July 22, 2020 (Amended September 10, 2020)

RE: Pine Canyon Well Fields Interference Analysis

LRE Water (LRE) is supporting Castle Rock Water (Town) with the evaluation of potential groundwater drawdown impacts from the development of the Pine Canyon Well Fields. LRE reviewed the Jehn Water report titled “*Water Supply Plan Report, Pine Canyon, Douglas County, Colorado*”, dated April 22, 2020 (Jehn Report). We reviewed preliminary well field planning from the Jehn Report and performed an independent evaluation of potential impacts to Castle Rock’s nearby wells.

CUMULATIVE DRAWDOWN FROM PINE CANYON WELLS IN LOWER DAWSON AQUIFER AFTER 100 YEARS OF PUMPING

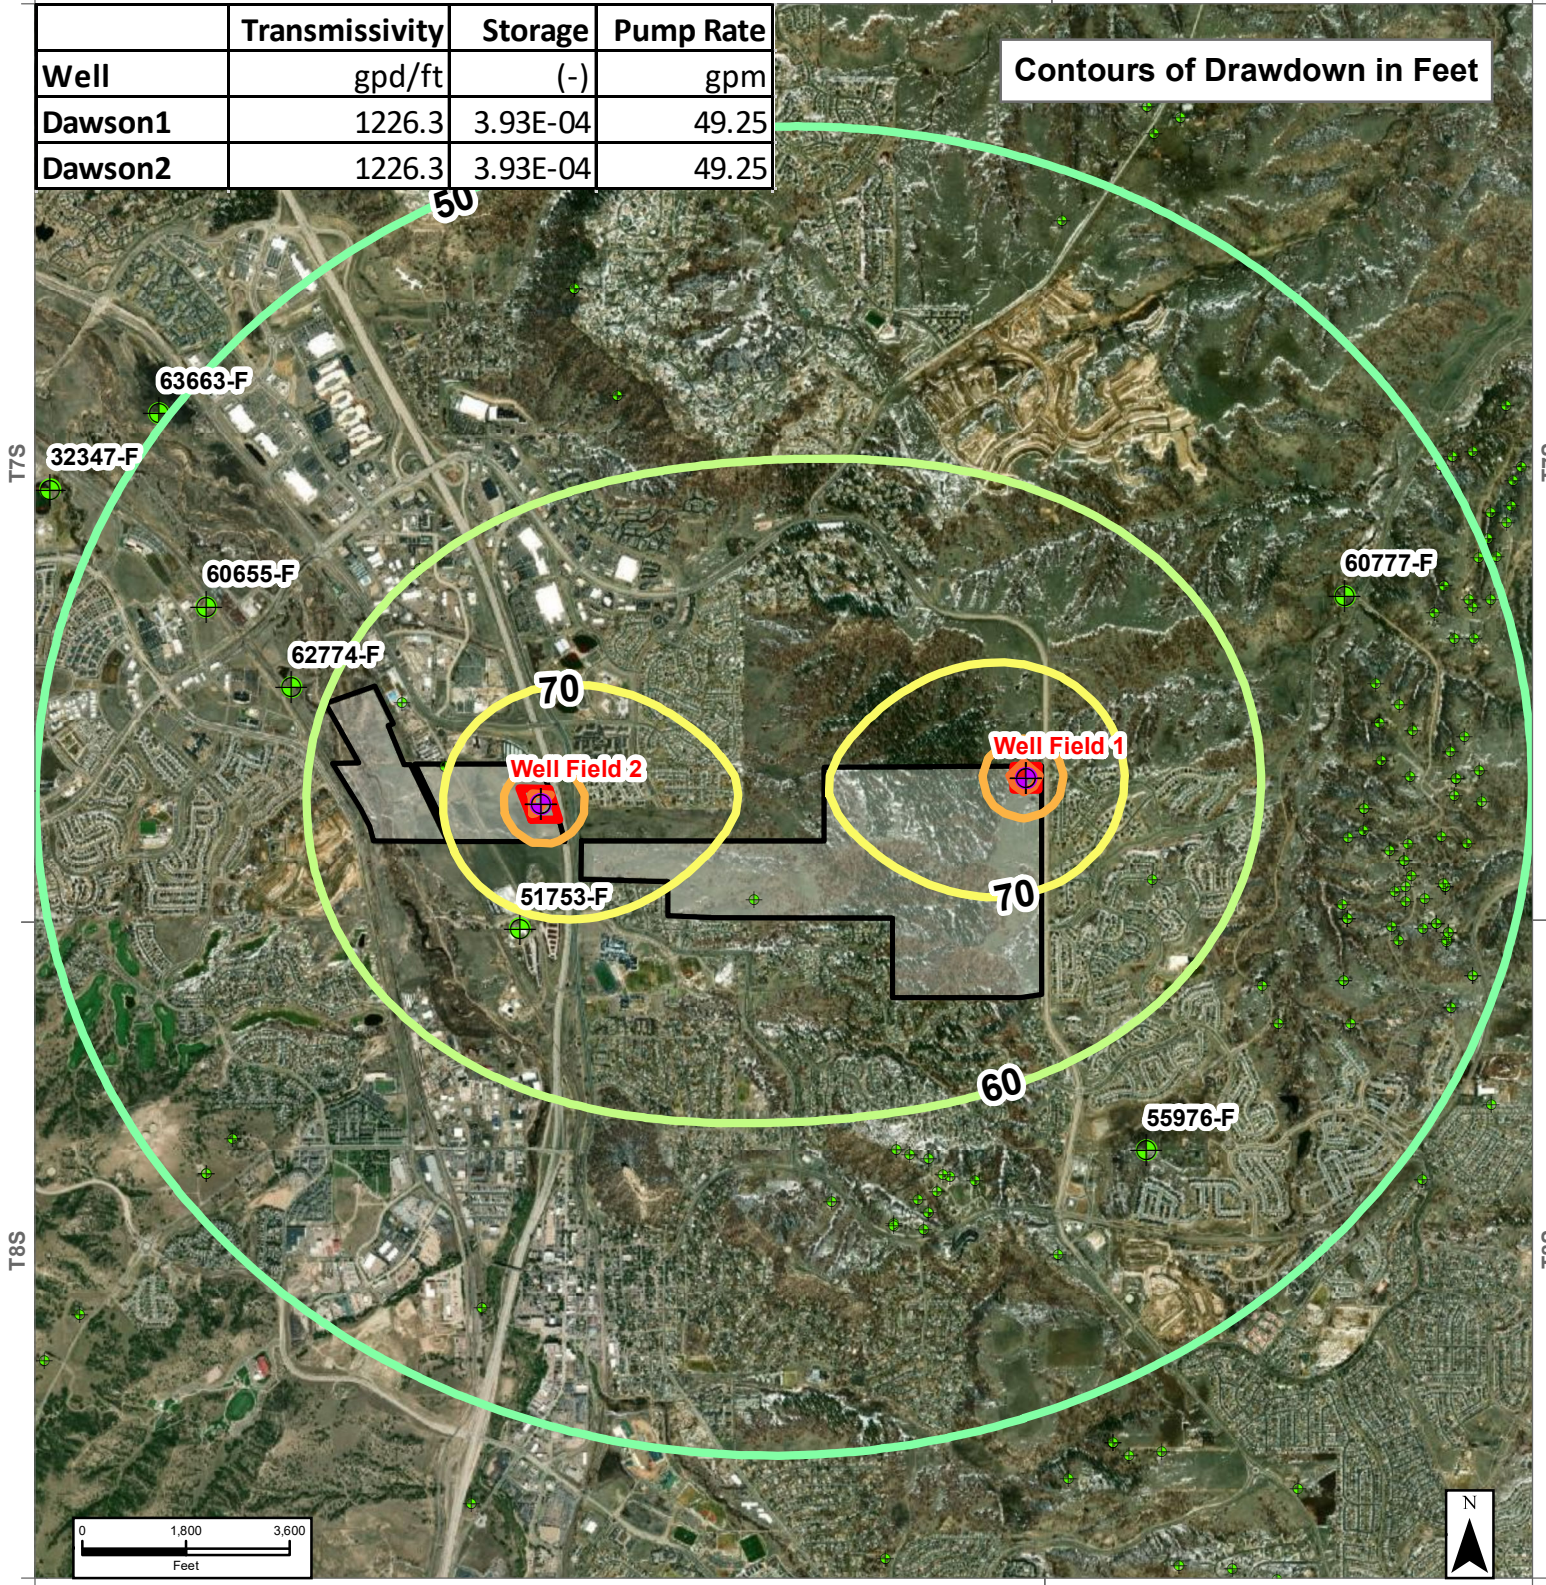
Figures 2, 3 and 4 show the regional aquifer response for the lower Dawson, Denver, and Arapahoe aquifers based on the parameters in **Table 1**. **Figures 2-4** show a pumping scenario where the full appropriation is split between the two proposed well fields (Well Fields 1 and 2) for a given aquifer, pumping constantly for 100 years. These figures show that many wells are affected by greater than 40 feet of drawdown which extends over a mile from the proposed Pine Canyon Well fields.

- LRE's estimated drawdown in the Town's wells due to 100 years of Pine Canyon well field pumping is over 56 feet in the Arapahoe aquifer, 69 feet in the Denver aquifer, and 82 feet in the Dawson aquifer.

- There are at least 6 Town wells completed in the Lower Dawson Aquifer, 18 wells completed in the Denver Aquifer, and 16 wells completed in the Arapahoe Aquifer that are within the 40 foot drawdown contour after 100 years of pumping of the proposed Pine Canyon wells from Well Fields 1 and 2.
